**Comments on the Draft Alternatives Screening Technical Memorandum  
Prepared by Geo-Hydro Inc. on behalf of  
People in Need of Environmental Safety**

Geo-Hydro Inc. (GHI) is submitting the following comments on the draft Alternatives Screening Technical Memorandum for the Pines Area of Investigation dated June 2012, on behalf of People In Need of Environmental Safety (PINES). Our general and specific comments on that document are provided below. The comments identify the most significant technical issues associated with the remedial action objectives (RAOs). GHI will further address these with PINES as the RI/FS process continues and concludes, thereby allowing PINES to fulfill its obligations to the public under the TAP.

## Boron Concentrations in Monitoring Wells Near Yard 520

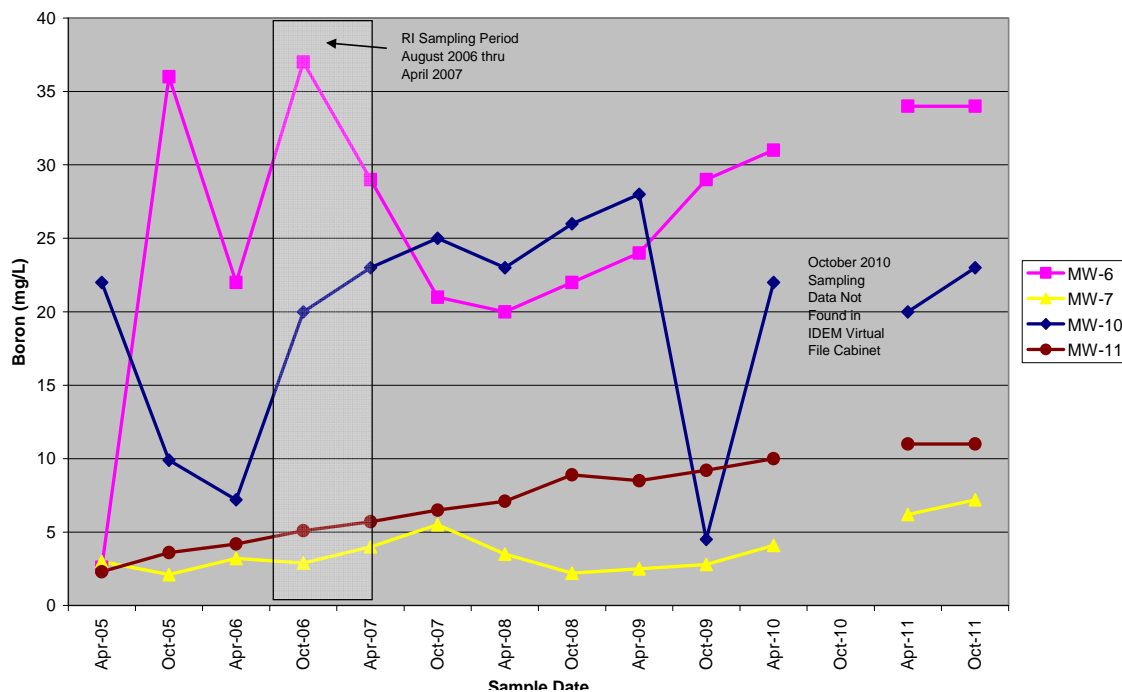
6. **Section 2.2.4, Page 2-9** – The discussion of hydraulic gradients and boron concentrations presented in this section is misleading. A statement is made that “Overall, there has been no significant change in groundwater levels or hydraulic gradients since completion of the RI field work.” There are no data to justify this statement, but, as discussed below, there are data that refute it. During the RI, rapidly increasing leachate head within North Yard 520 was documented in the only piezometer (PZ001) capable of measuring changes in head within the landfill. This piezometer was immediately abandoned following completion of RI sampling events, allowing no possible inference that head levels had reached the maximum and subsequently remained static. GHI has repeatedly warned that concentrations of CCB-related contaminants in groundwater may increase outside the landfill units over time solely due to the observed increase in mounded leachate elevation. Concentration increases may be compounded as disposed CCBs continue to weather and chemically evolve. Increasing leachate head within the landfill will have the effect of driving more flow of leachate outward in all directions, including toward the north and northwest toward IDNL, and increasing concentrations of CCB-related contaminants in groundwater over that observed during the RI.

In order to investigate recent changes in groundwater quality in the immediate vicinity of Yard 520 GHI accessed semi-annual monitoring results submitted to IDEM. Reported boron and sulfate concentrations from a subset of monitoring wells located in the immediate area of North Yard 520 were plotted. The plot of reported boron data (below) shows that concentrations have remained very high in some wells (MW-6 and MW-10) and has been generally increasing in others (MW-7 and MW-11) since the RI sampling program was completed. This indicates that contrary to the description of declining boron concentrations provided in the Alternatives Screening Memorandum, areas impacted by CCB-derived constituents in some wells near the source are increasing as anticipated.

## Sulfate Concentrations in Monitoring Wells Near Yard 520

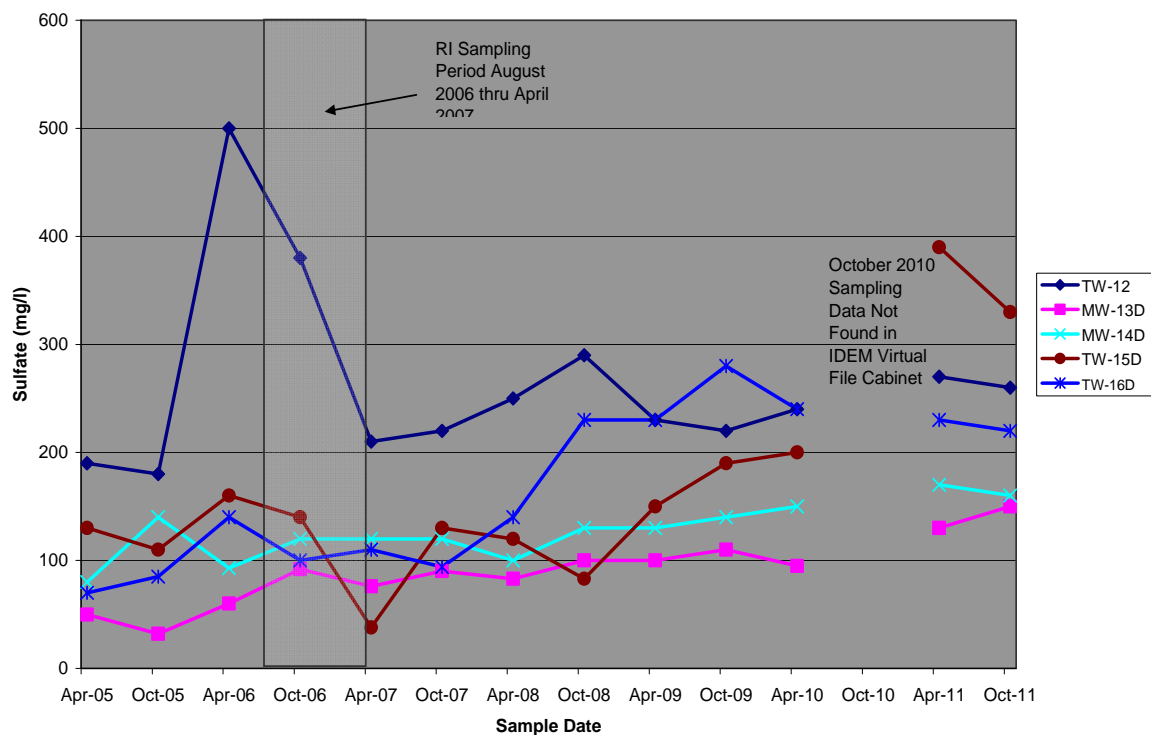
The plot of reported sulfate data (below) shows generally increasing sulfate concentrations in each plotted well since the RI sampling program was completed. This data provides another indication of increasing CCB-derived groundwater impacts in the vicinity of Yard 520.

These data plots do not represent a comprehensive evaluation of groundwater quality since completion of the RI. They simply provide an indication of the misleading nature of the discussion of post-RI sampling results presented in the Alternatives Screening Memorandum. If left unchecked, increased concentrations of CCB-related contaminants coupled with increasing leachate head and CCB diagenesis will spread CCB-related contaminants in all directions from Yard 520, leading to increased concentrations of these constituents in wells at greater distances from the landfills.
